Supplementary Water Management Report

& Response to Contentions
For a Proposed Residential Development

Project address: Lots 1 & 2 in DP 349085 (No. 45-49) and Lot 2 in DP 972209 (No.43)
Warriewood Road, Warriewood

Document No.: CC230177_WMP

DR01 - LONGITUDINAL SECTION
HORZ SCALE 1:500
VERT SCALE 1:250

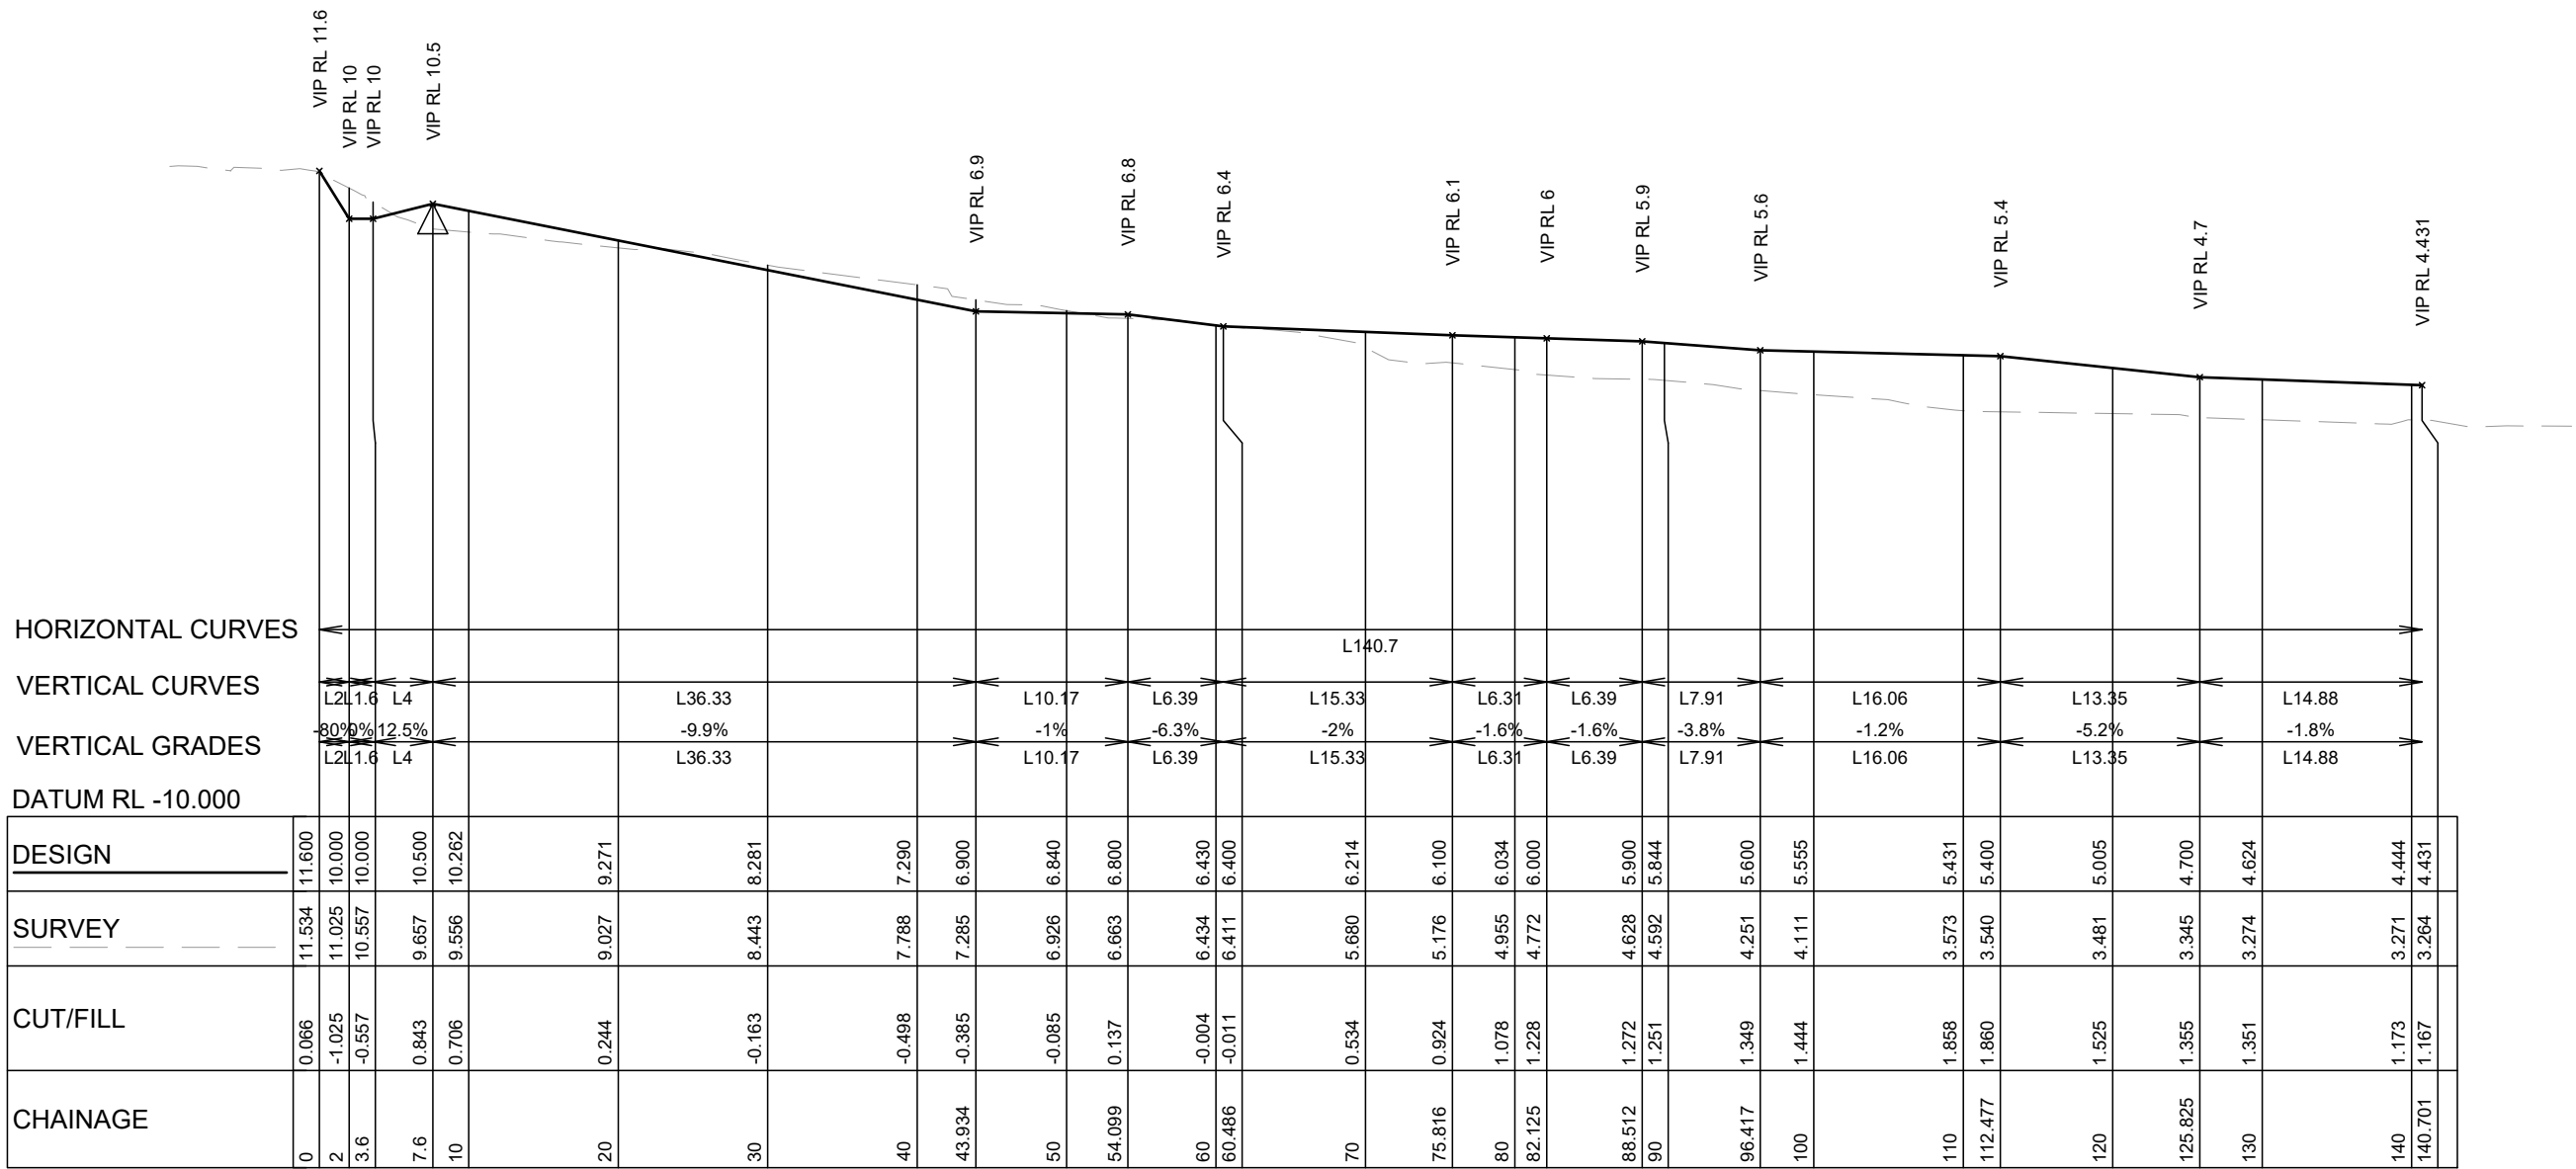
3.a.iv	The Applicant has not provided sufficient detail with respect to the design of the overland flow path over the proposed stormwater line within the existing drainage reserve. Cross sections are required along the overland flow path to detail the 1& AEP Top Water Levels and to ensure that all habitable areas are a minimum of 500mm above these levels.	We refer to our response to contention 3.a.ii and note that a revised design and associated DRAINS model has been prepared which demonstrates the system depicted on our revised civil engineering plans can sufficiently capture and convey 100 Year ARI + CC30 flows through the site.

LONG SECTION (100YR ARI + CC)
DRAINAGE LINE 3

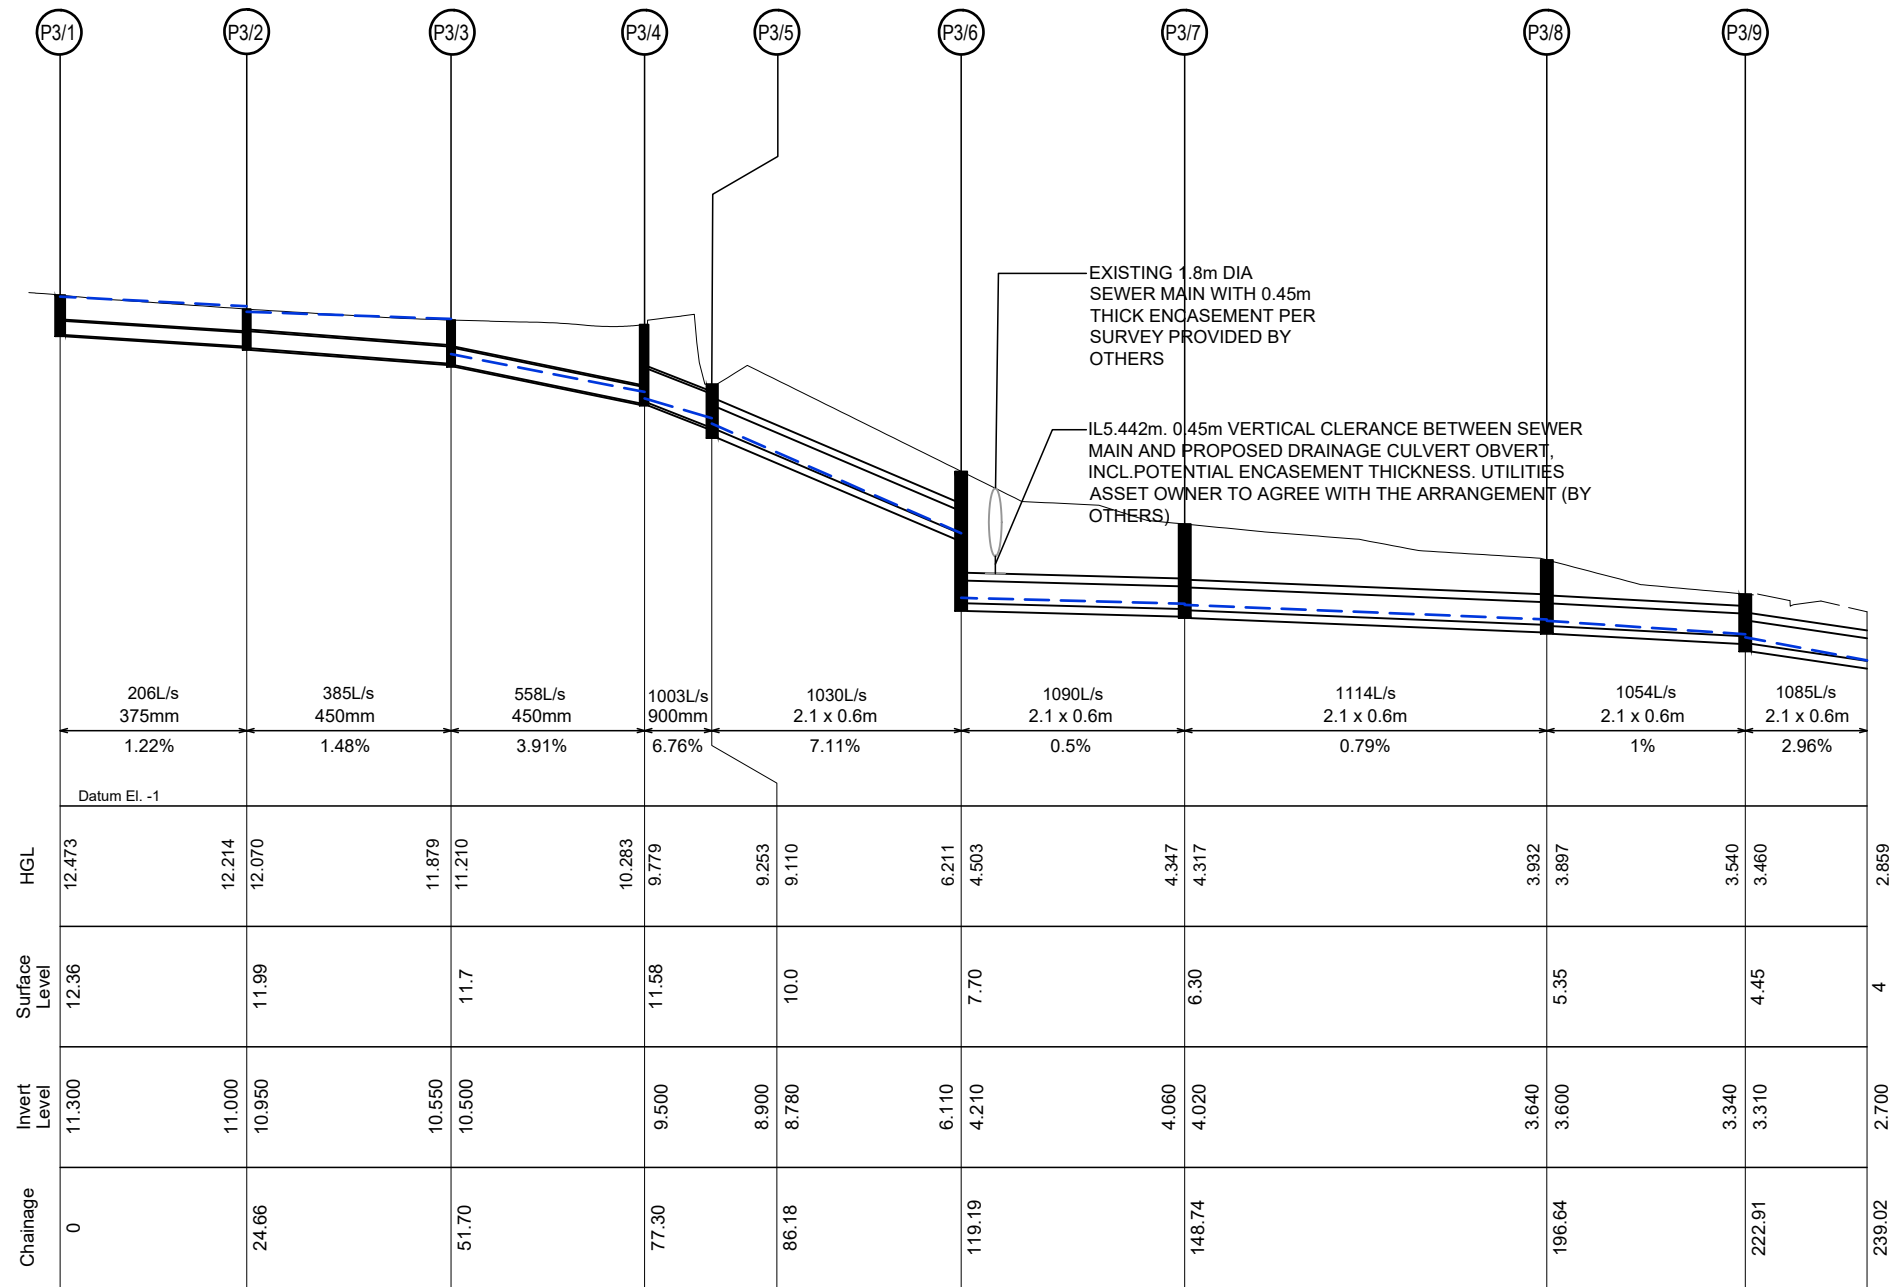
3.a.vii	The development application is not supported by sufficient long sections of stormwater lines, required to detail surface levels, the location of the pipe, the hydraulic grade line, velocities, and flows.	We refer to our revised civil engineering plans and note that a revised stormwater drainage long section has been document. The long section includes a hydraulic grade line analysis for the 100 Year ARI flows plus Climate Change.

OUTLET AND ENERGY DISSIPATION SWALE - BASIN 2
NOT TO SCALE

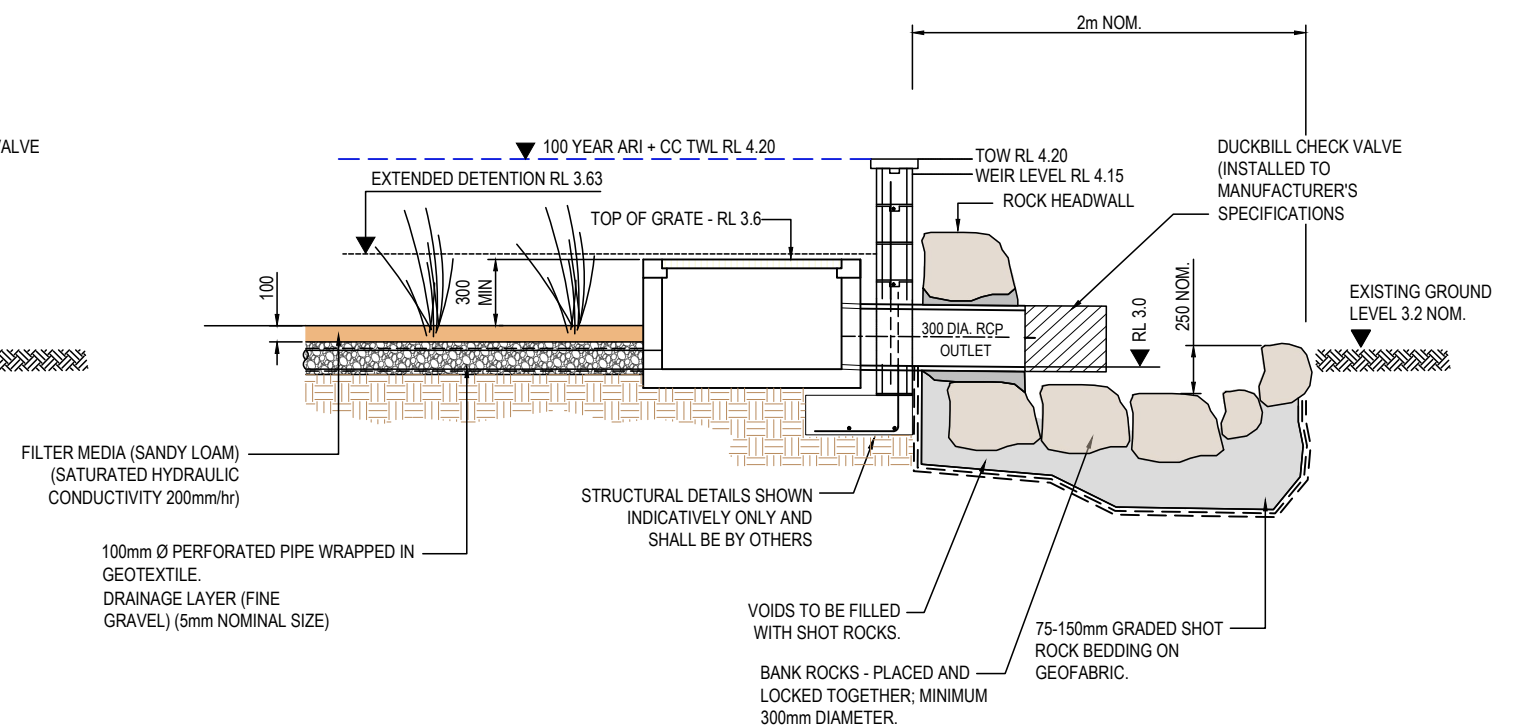
3.a.xiv	The proposed infiltration basin has a weir to control the outflow. The Applicant has not demonstrated that this is an appropriate outlet method in light of the groundwater dependent EEC along the creek line.	We refer to our document CC230177, sheets C1.00 to C4.03 (26 sheets), revision C, dated 6 March 2024 and note that weir overflows are proposed to an energy dissipation swale. This method has been discussed with Council's representatives in concept and are documented on our revised civil engineering plans. We understand this is a satisfactory outcome resulting in minimal impact to the EEC.

Both proposed detention basins discharge into a specifically designed energy dissipation and level spreader system. The detail of the system is depicted on Civil Engineering Plans prepared by ACOR Consultants Pty Ltd, Reference CC230177, Sheets C3.05 & C3.06, Revision C, dated 6 March 2024 (copy enclosed under Annexure A) and generally comprises 2 m wide rock lined swale designed to dissipate flows at the existing natural surface level downstream of the basins.
